1906 20TH AVE S
SDCI #3037697-LU
Design Review Board Recommendation Meeting
June 28, 2022

EDG RESPONSE

Commercial Entries

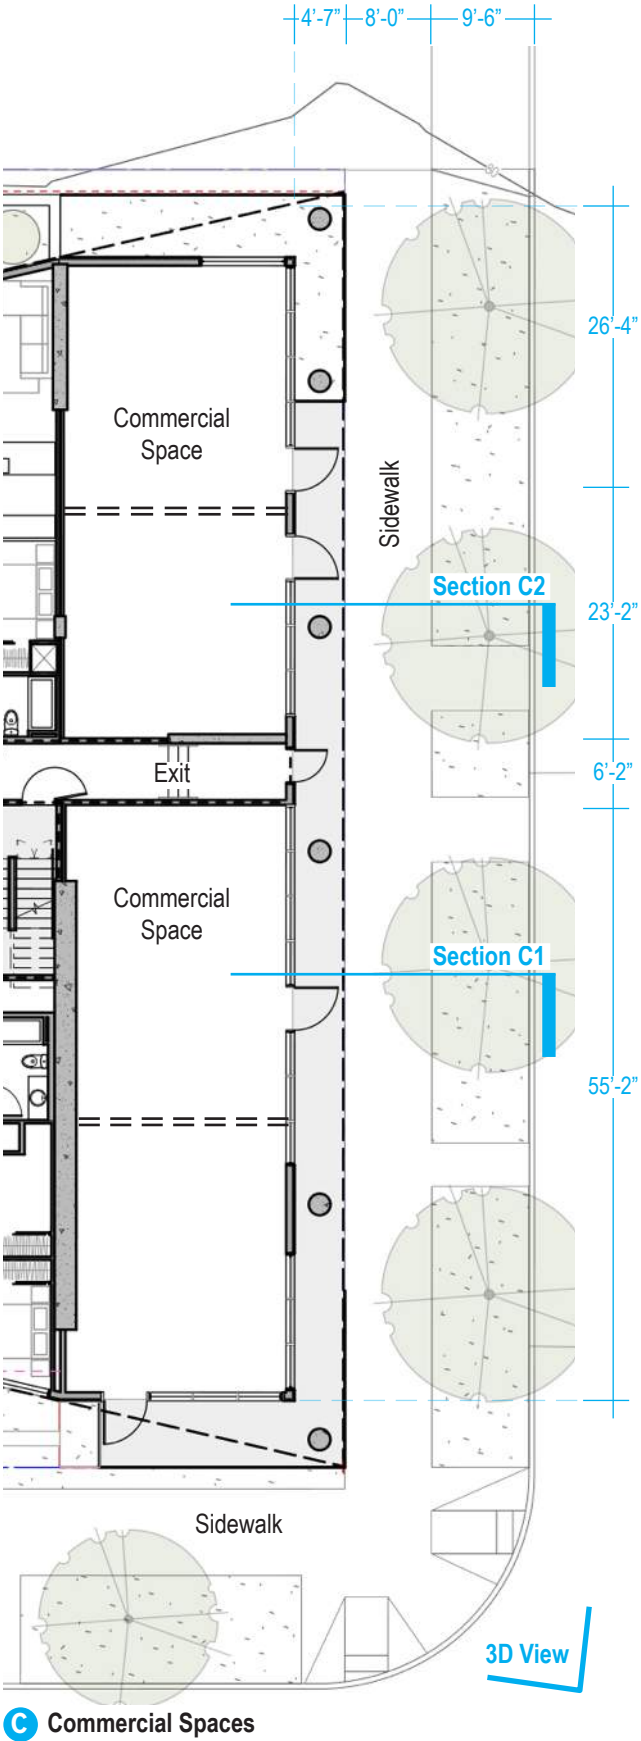
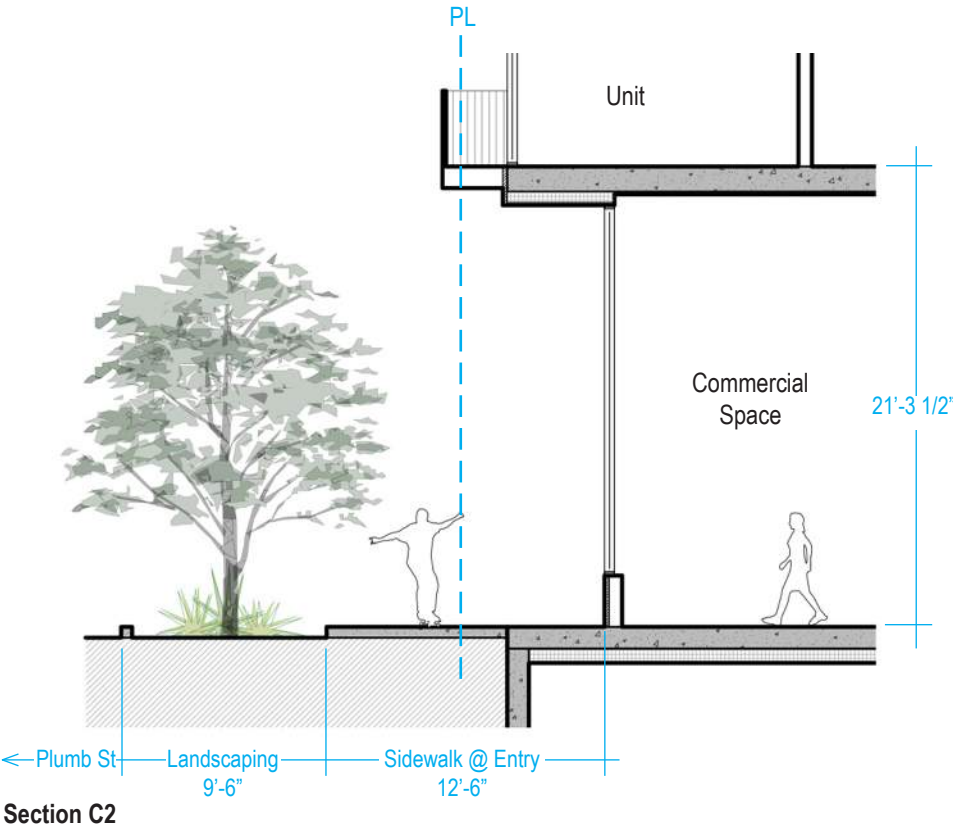
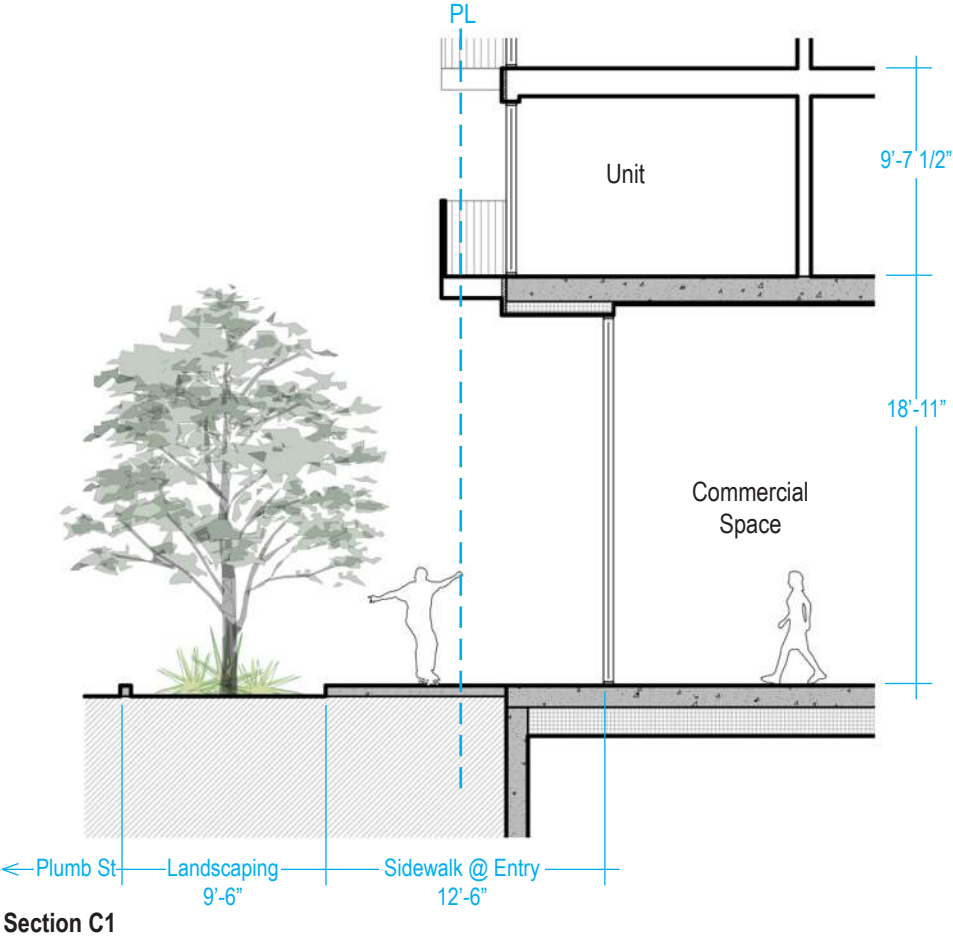
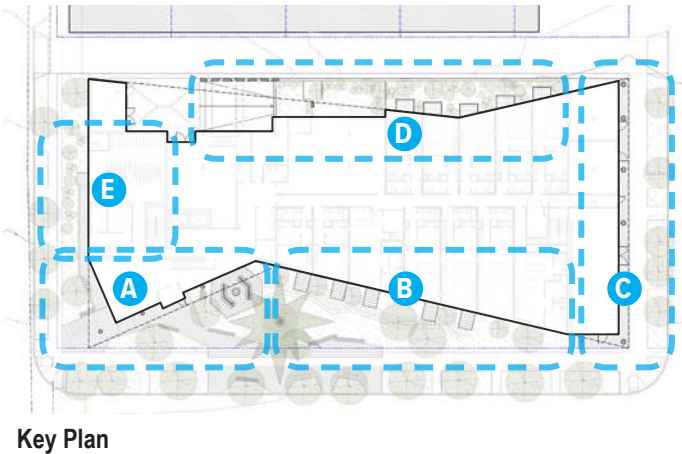
- 2a. The Board supported residential expression along the west façade where the project faces a residential zone and commercial expression along the north and south street frontages where ground-level commercial spaces are currently proposed. The Board requested examination at the Recommendation phase of review to show *how the distinct residential and commercial scales are expressed within the building design through materials and secondary architectural features* (PL2-D-1. Design as Wayfinding, DC2-C-1. Visual Depth and Interest, DC2-D-1. Human Scale, DC2-E-1. Legibility and Flexibility).

- 2b. Related to the guidance above for the design of ground-level uses, the Board requested ground-level perspective drawings along the street frontages to show the character of street frontages, the building design relationship to wayfinding, and the *relationships of ground-floor uses to each other and the street frontage* (PL2-D-1. Design as Wayfinding, PL3-C-1. Porous Edge, DC1-A. Arrangement of Interior Uses, DC2-D-1. Human Scale).

- 2a. In contrast to the primary building entry and commercial portion, the residential portion has a distinctly different facade treatment and scale. See plans, sections, and ground level renderings showing the different street level uses in this project. **A** Residential Entry **B** Residential Units **C** Commercial Spaces **D** Alley and **E** Bike Entry.

- The commercial spaces are double height but expressed differently from the residential entry as black aluminum storefront with commercial storefront signs. The face of the commercial spaces are also set back from the units above creating a distinctly different massing at the ground floor.

- 2b. Each of the ground level uses in this project will have a different character and relationship to the street. The plaza courtyard created around the Douglas Fir provides a privacy buffer from the ground floor residential use and the primary building entry is expressed as double height space close to the edge of the property. Refer to the street level use plan and section diagrams for the **A** Residential Entry **B** Residential Units **C** Commercial Spaces **D** Alley and **E** Bike Entry.

Refer to the rendering at right showing the ground level character of the commercial spaces.

Residential Units on Alley

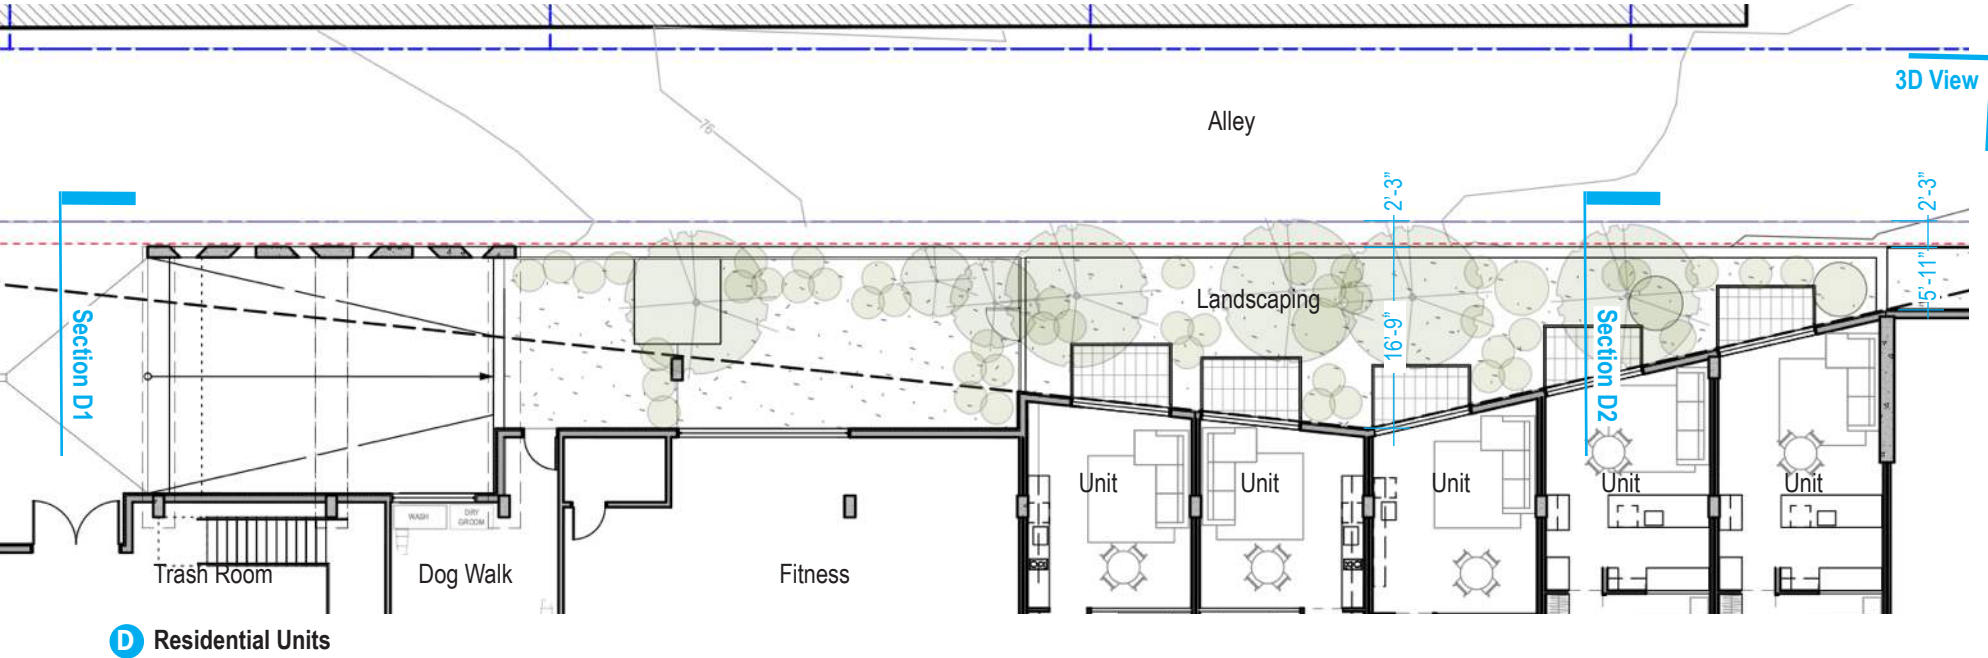
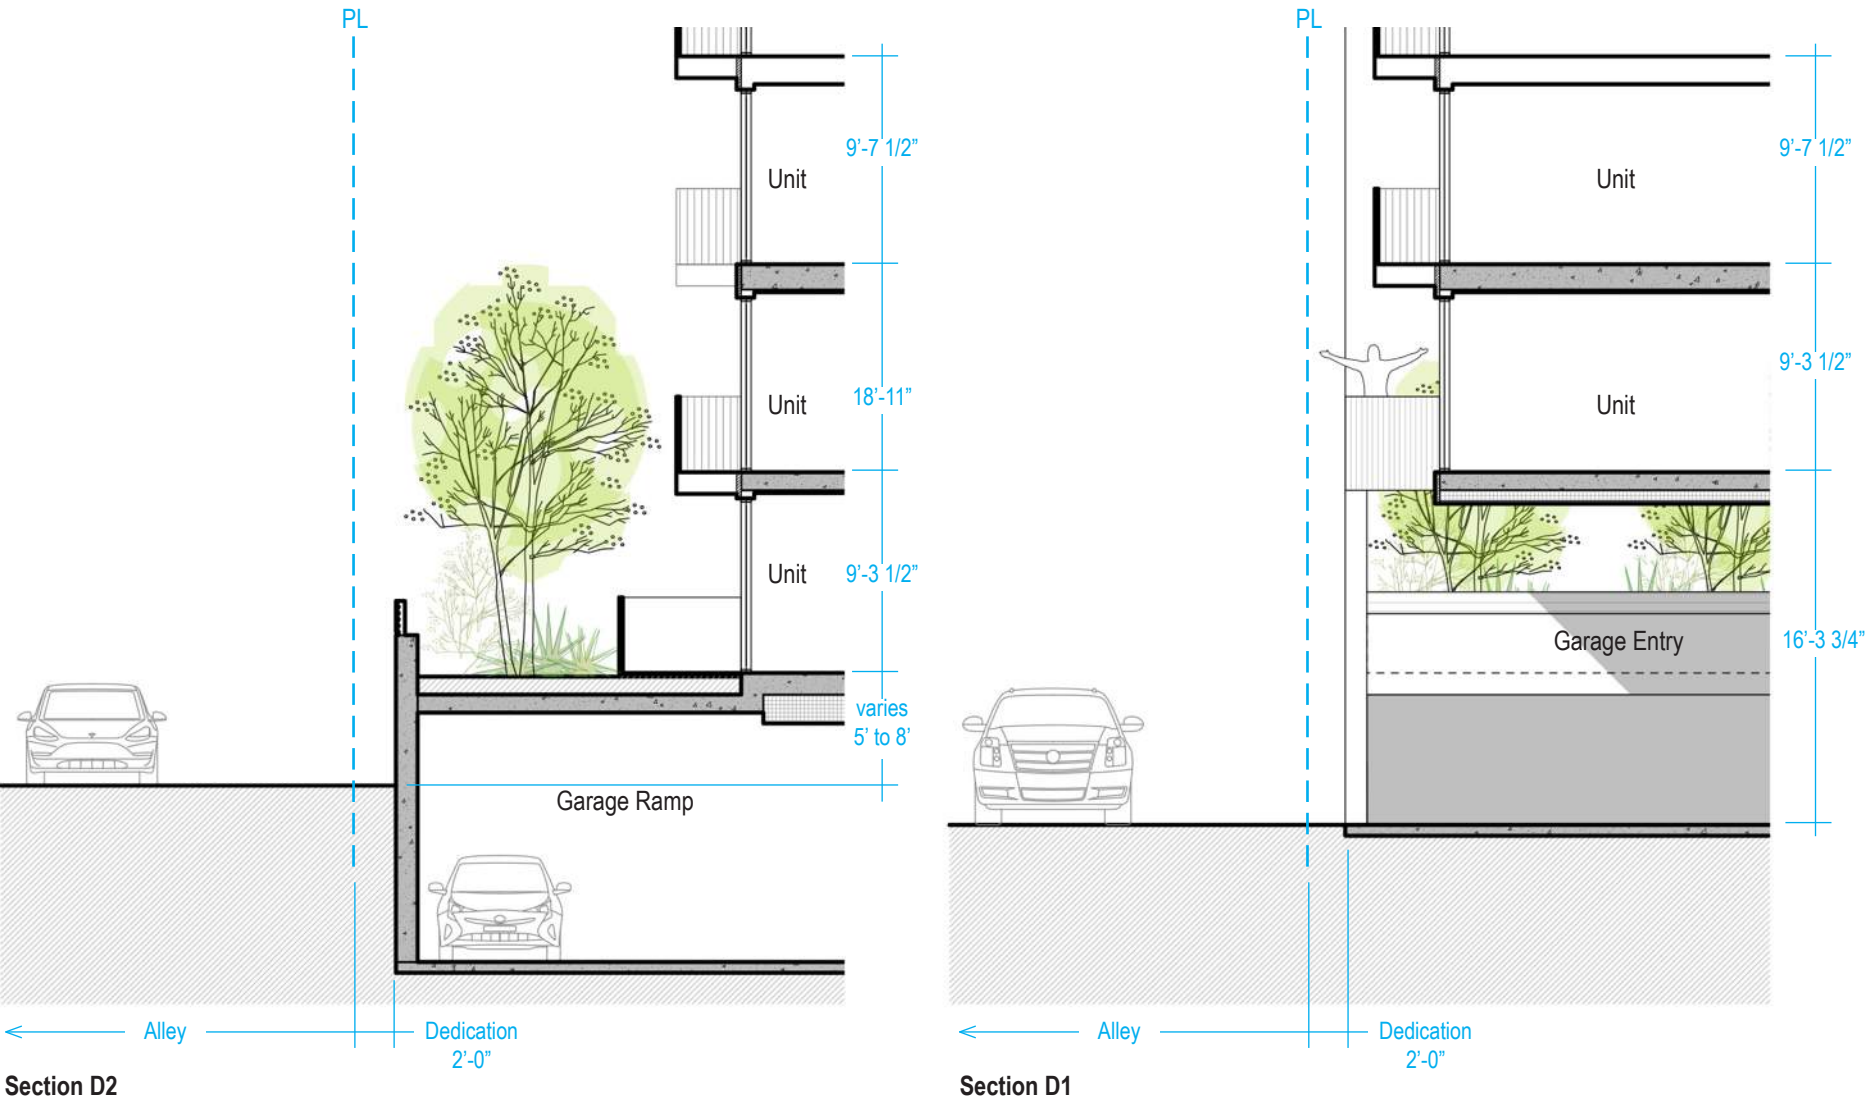
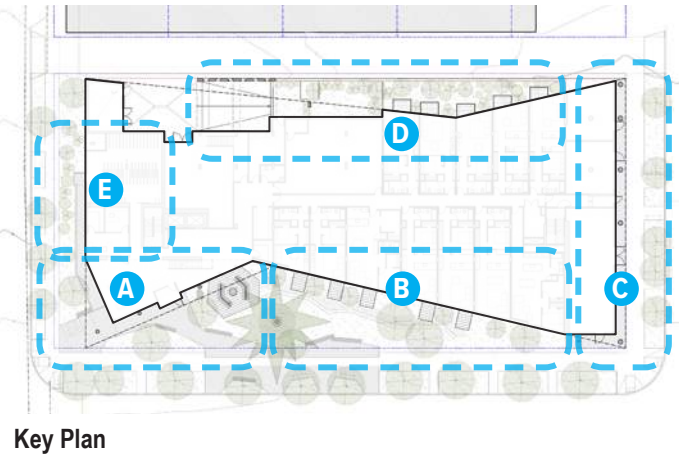
- 2a. The Board supported residential expression along the west façade where the project faces a residential zone and commercial expression along the north and south street frontages where ground-level commercial spaces are currently proposed. The Board requested examination at the Recommendation phase of review to show *how the distinct residential and commercial scales are expressed within the building design through materials and secondary architectural features* (PL2-D-1. Design as Wayfinding, DC2-C-1. Visual Depth and Interest, DC2-D-1. Human Scale, DC2-E-1. Legibility and Flexibility).

- 2b. Related to the guidance above for the design of ground-level uses, the Board requested ground-level perspective drawings along the street frontages to show the character of street frontages, the building design relationship to wayfinding, and the *relationships of ground-floor uses to each other and the street frontage* (PL2-D-1. Design as Wayfinding, PL3-C-1. Porous Edge, DC1-A. Arrangement of Interior Uses, DC2-D-1. Human Scale).

- 2a. In contrast to the primary building entry and commercial portion, the residential portion has a distinctly different facade treatment and scale. See plans, sections, and ground level renderings showing the different street level uses in this project. **A** Residential Entry **B** Residential Units **C** Commercial Spaces **D** Alley and **E** Bike Entry.

- The residential units at the alley side are up away from traffic and set back with a landscape bed. Patios at the lower level are integrated into the landscaping and trees which also provide a buffer. The materials on the alley side residential units are consistent with those on other faces of the building.

- 2b. Each of the ground level uses in this project will have a different character and relationship to the street. The plaza courtyard created around the Douglas Fir provides a privacy buffer from the ground floor residential use and the primary building entry is expressed as double height space close to the edge of the property. Refer to the street level use plan and section diagrams for the **A** Residential Entry **B** Residential Units **C** Commercial Spaces **D** Alley and **E** Bike Entry.

Refer to the rendering at right showing the character of the alley side residential units.

Holgate Sidewalk

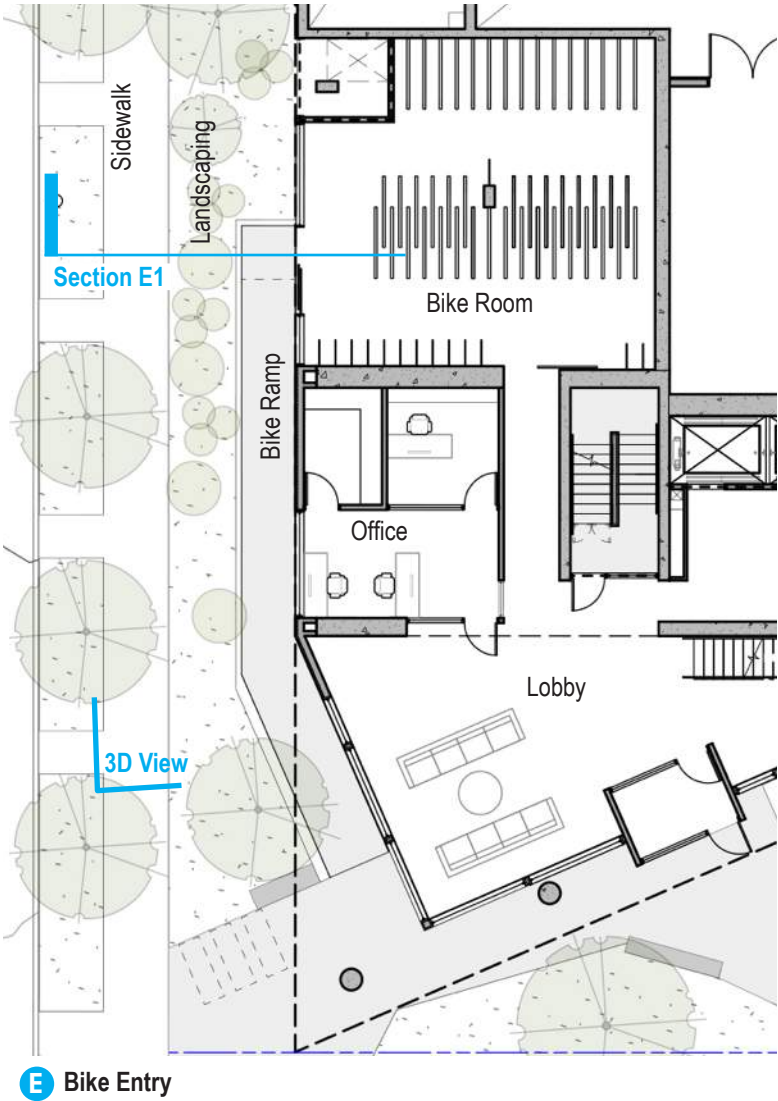
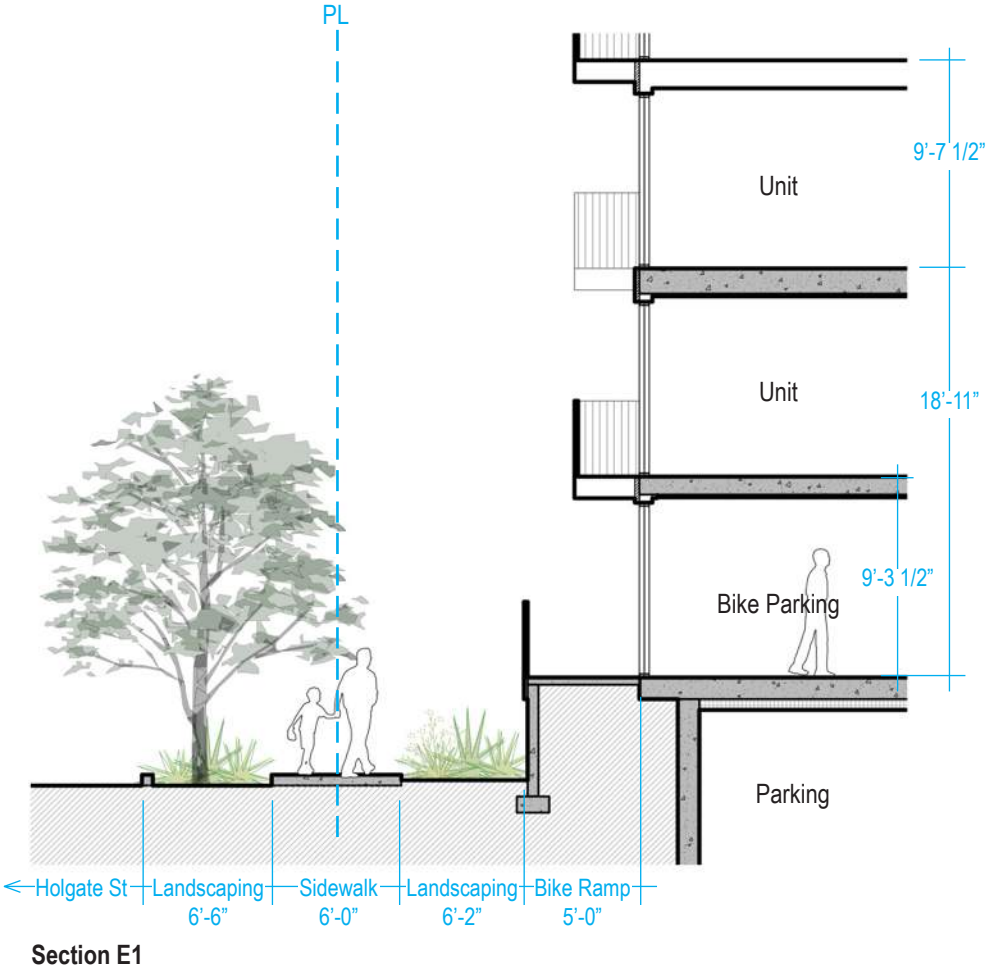
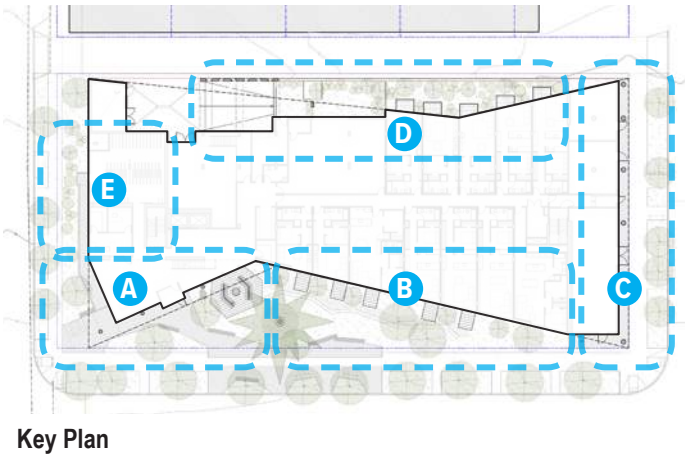
- 2a. The Board supported residential expression along the west façade where the project faces a residential zone and commercial expression along the north and south street frontages where ground-level commercial spaces are currently proposed. The Board requested examination at the Recommendation phase of review to show *how the distinct residential and commercial scales are expressed within the building design through materials and secondary architectural features (PL2-D-1. Design as Wayfinding, DC2-C-1. Visual Depth and Interest, DC2-D-1. Human Scale, DC2-E-1. Legibility and Flexibility).*

- 2b. Related to the guidance above for the design of ground-level uses, the Board requested ground-level perspective drawings along the street frontages to show the character of street frontages, the building design relationship to wayfinding, and the *relationships of ground-floor uses to each other and the street frontage (PL2-D-1. Design as Wayfinding, PL3-C-1. Porous Edge, DC1-A. Arrangement of Interior Uses, DC2-D-1. Human Scale).*

- 2a. In contrast to the primary building entry and commercial portion, the residential portion has a distinctly different facade treatment and scale. See plans, sections, and ground level renderings showing the different street level uses in this project. **A** Residential Entry **B** Residential Units **C** Commercial Spaces **D** Alley and **E** Bike Entry.

- The bike access is located on the north facade at the lobby level, due to existing grade conditions the bike room is accessed by a ramp that starts near the residential entrance. The bike room is a single story tall and has storefront glass that makes for a visually identifiable bike room.

- 2b. Each of the ground level uses in this project will have a different character and relationship to the street. The plaza courtyard created around the Douglas Fir provides a privacy buffer from the ground floor residential use and the primary building entry is expressed as double height space close to the edge of the property. Refer to the street level use plan and section diagrams for the **A** Residential Entry **B** Residential Units **C** Commercial Spaces **D** Alley and **E** Bike Entry.

Refer to the rendering at right showing the bike access, facade treatment, and landscape buffer.
